Commission of Architectural Review

3. COA-182849-2026	Final Review	Meeting Date: 4/28/2026
Applicant/Petitioner	Thomas Baiada	
Project Description	Construct a new rear deck	
Project Location		
Address: 506 N 26th Street		
Historic District: Church Hill North		
<p>High-Level Details:</p> <p>The subject building is an attached, masonry, Italianate style building.</p> <p>The applicant proposes to remove a non-original, raised, rear deck with nailed-up pickets, and to construct a new wider and shallower raised deck in the same location.</p> <p>The new deck will be approximately 10 feet in depth and 14 ft wide and will feature simple banisters and posts with horizontal wire railings for a contemporary appearance. A spiral staircase will be installed off the deck and into the rear yard.</p>		
Staff Recommendation		
Staff Contact	Alex Dandridge, Alex.Dandridge@RVA.gov, (804)646-6569	
Previous Reviews	<ul style="list-style-type: none"> Review

Figure 3. Proposed Deck.

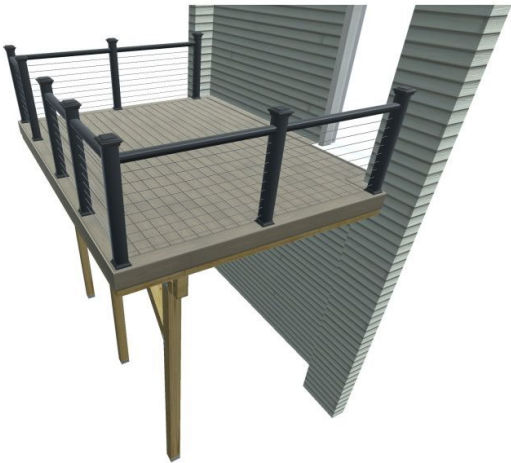
Staff Recommendations	<ul style="list-style-type: none"> Wooden elements on the deck be painted or stained a color that complements colors found on the extant building after appropriate weathering has taken place. Sub-decking under the deck be screened, final means of screening submitted for staff review. Deck fasteners be camouflaged or hidden for a more finished appearance.
